**CITY OF TEMPE
DEVELOPMENT REVIEW COMMISSION**

Meeting Date: 10/27/2015
Agenda Item: 6

ACTION: Request for an Amended Planned Area Development and Development Plan Review consisting of a new parking structure for **OPERATIONS CENTER (PL150368)**, located at 1305 West 23rd Street. The applicant is Mesfin Samuel of The Samuel Group.

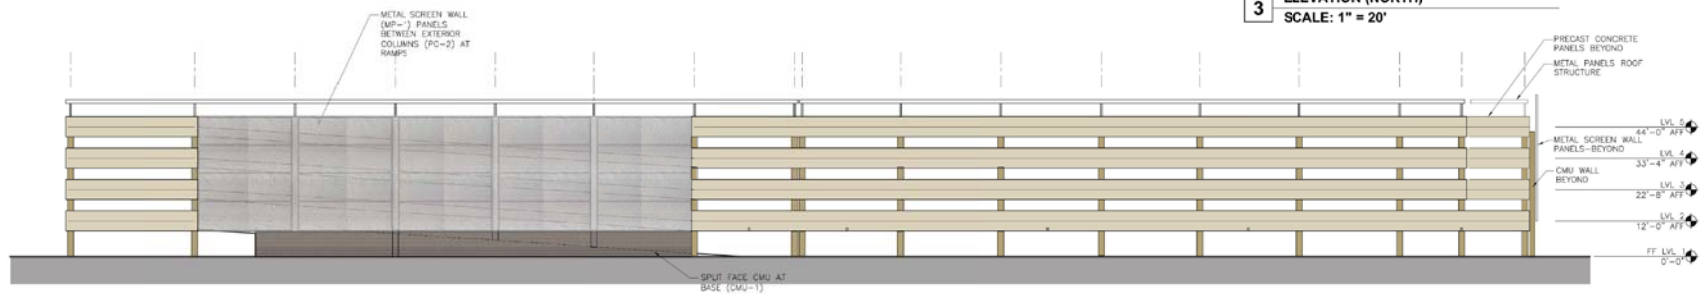
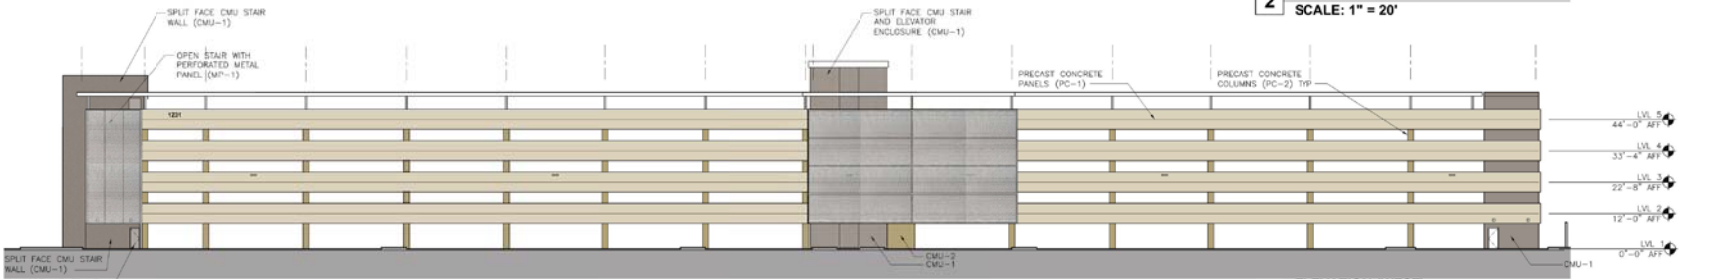
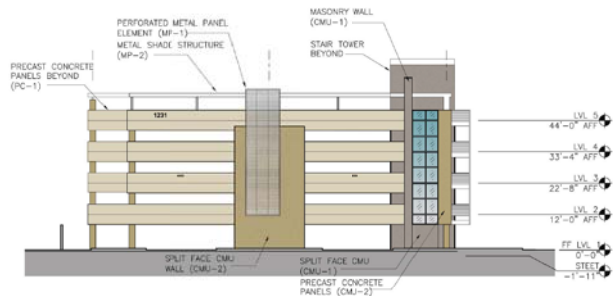
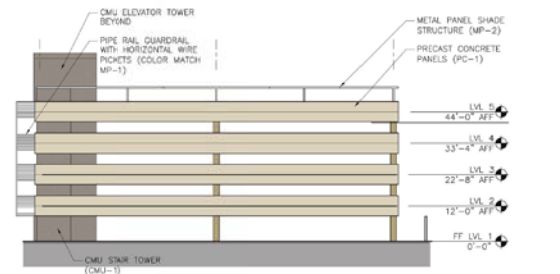
10. The materials and colors are approved as presented (dated September 30, 2015):
 - Primary Building – PC-1 - Precast Concrete Panels (spandrels and walls) Mitsubishi White (limestone color w/ white inclusions)

- Secondary Building – PC-2 - Precast Concrete Columns to match CMU-2 (medium desert tan cmu color)
 - Stair Tower – CMU-1 – Superlite Charcoal Split Faced Concrete Masonry Unit (dark cool grey)

- Building Accent Elevator and Electrical Room enclosure – CMU-2 – Superlite Tierra Brown Split Faced Concrete Masonry Unit (medium desert tan)
 - Metal Curtain Wall - AL1 – Aluminum Metal Curtain Wall Frame Clear Anodized

- Perforated Metal Channel Panel System – MP-1 - Morin Matrix Series MX 1 ½" panel depth 40% open perforated metal panel 22 inch gauge bright silver with concealed fasteners, horizontally mounted.

- Metal Curtain Wall - MP-2 – Morin Matrix Series MX 1.0 Metal Panel solid, 22 inch gauge bright silver to match shape of MP-1
 - Glazed Curtain Wall – GL-1– Pilkington Eclipse Advantage Blue-Green with clear anodized aluminum metal frame system

- Metal Shade Canopies – MP-2 - Morin Matrix Series MX 1.0 metal panel 22 inch gauge bright silver to match shape of MP-1.

Provide primary building colors and materials with a light reflectance value of 75 percent or less. Specific colors and materials exhibited on the materials sample board are approved by planning staff. Additions or modifications may be submitted for review during building plan check process.
